HISTORIC PRESERVATION BOARD

**PUBLIC HEARING
21 ORCHARD STREET**

TO: Chair Sheridan and Members of the Historic Preservation Board
FROM: Deb Andrews, Historic Preservation Program Manager
DATE: May 28, 2020
RE: June 3, 2020 PUBLIC HEARING

Application for: Certificate of Appropriateness for Second-Floor Sunporch
Addition, Two Deck Additions

2	PROPOSED SW ELEVATION (SIDE)
A201	1/4" = 1'-0"

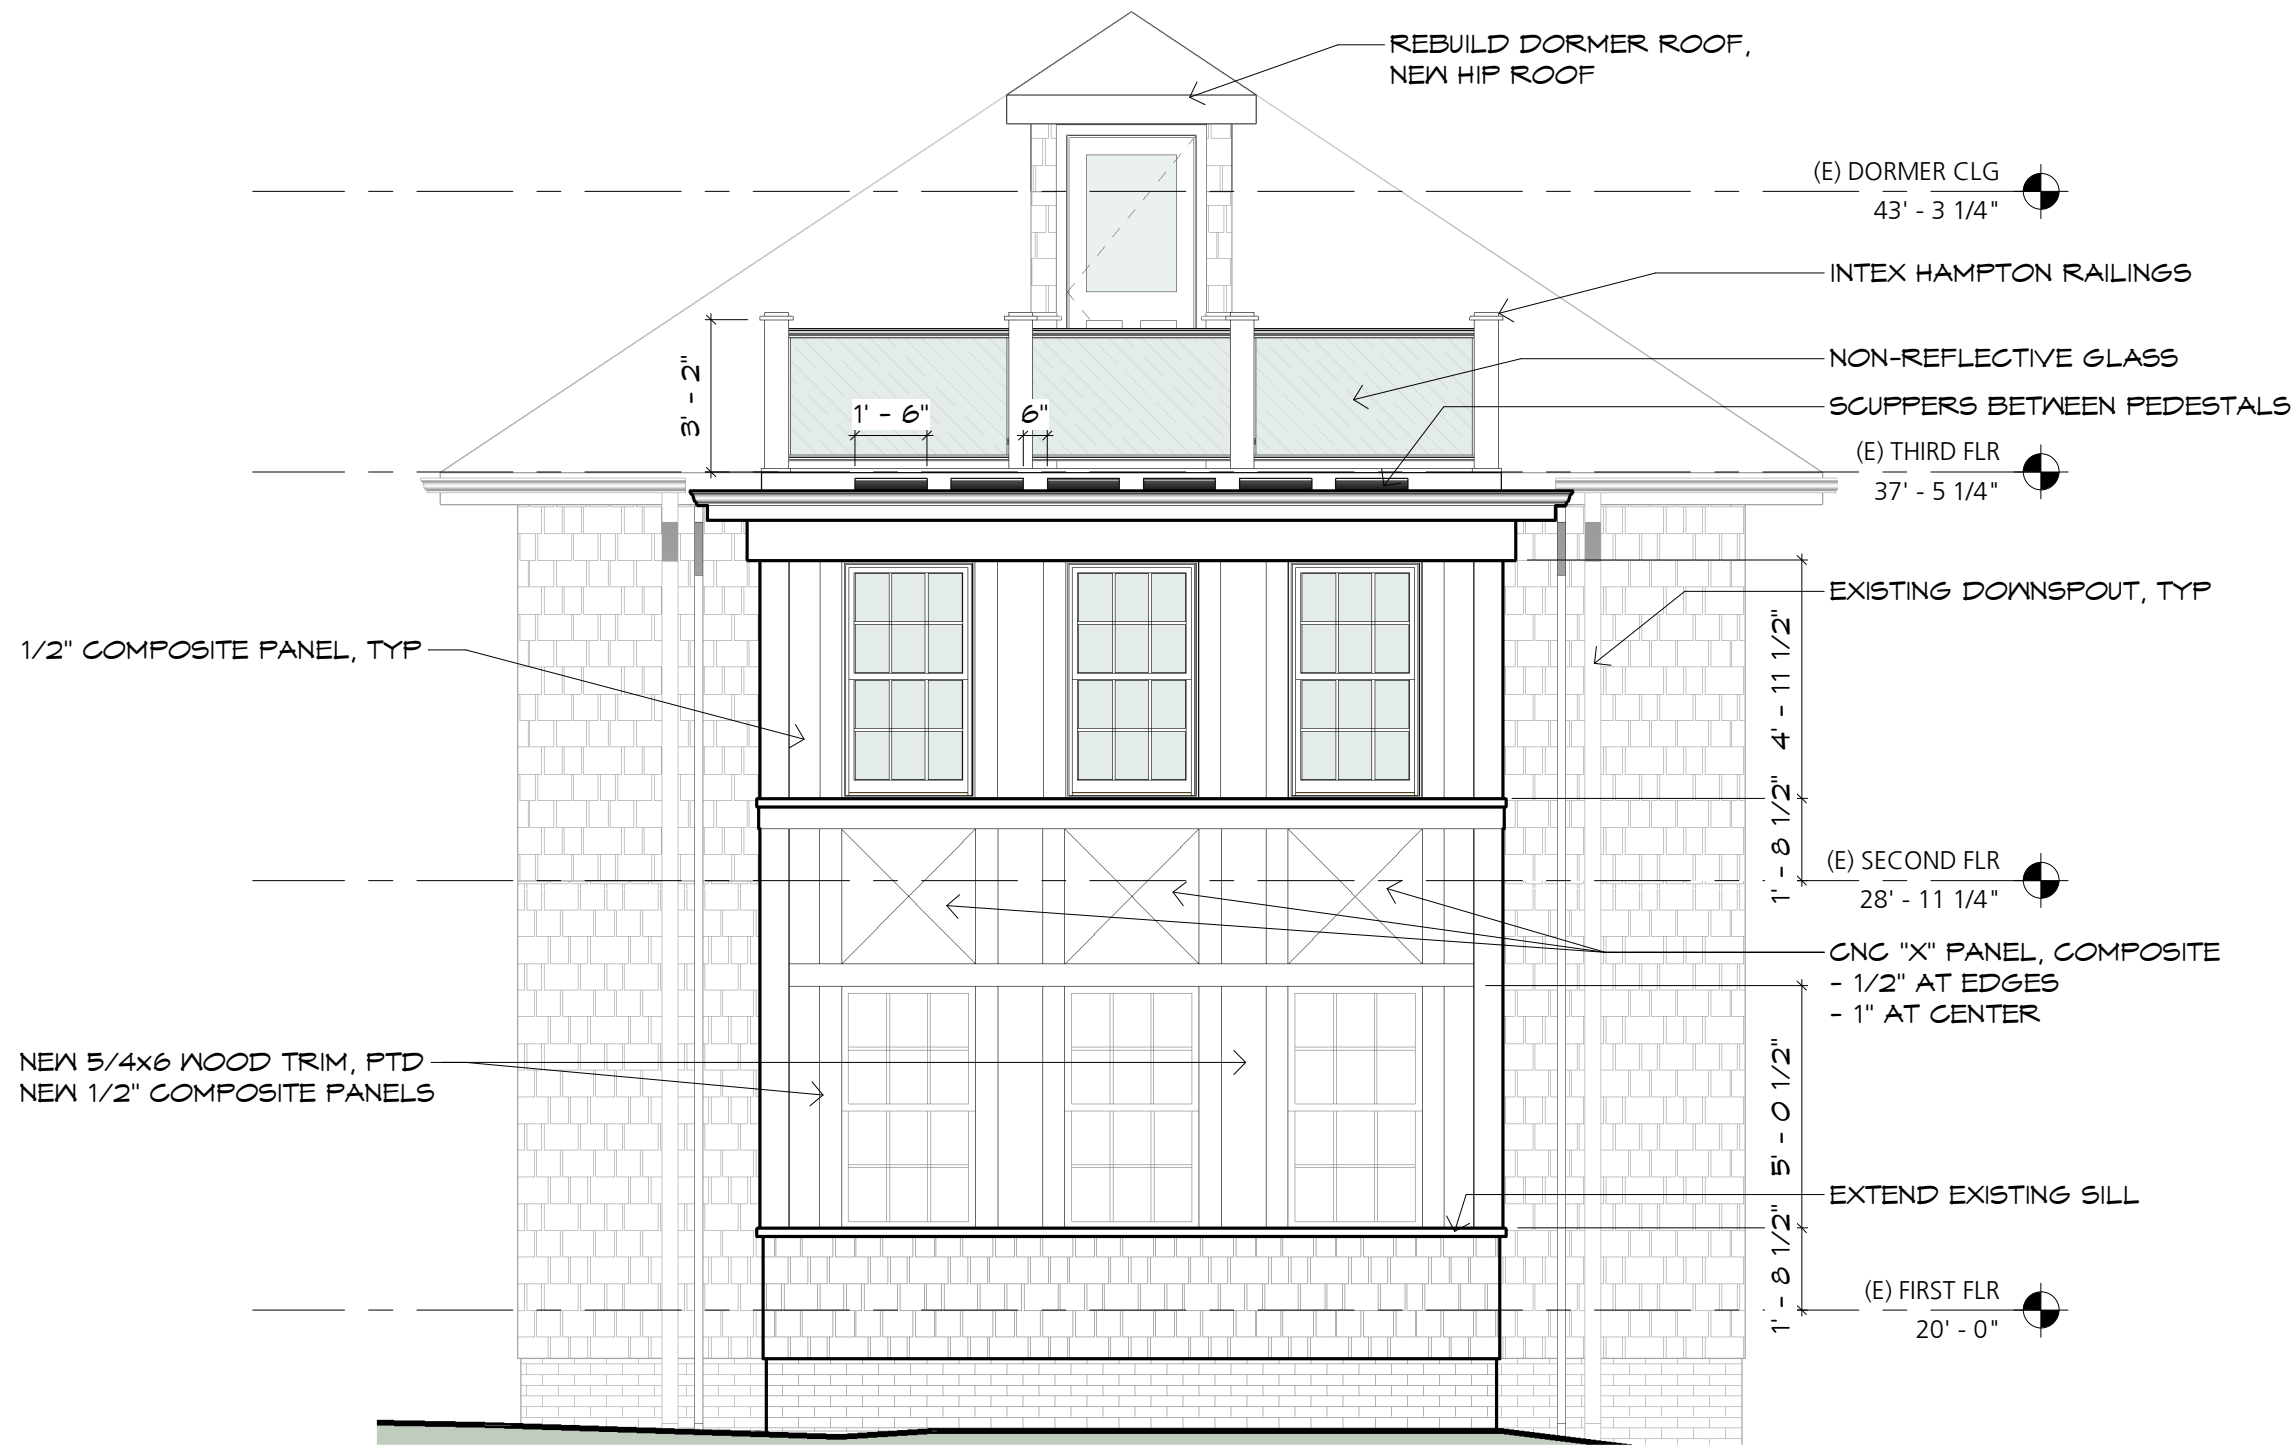
panels between posts. The glass panels will be set within a top and bottom rail. A natural finish mahogany top rail is proposed. The elevations show a standard balustered railing adjacent to the roof. Board members should confirm whether this change is intentional or a drafting error.
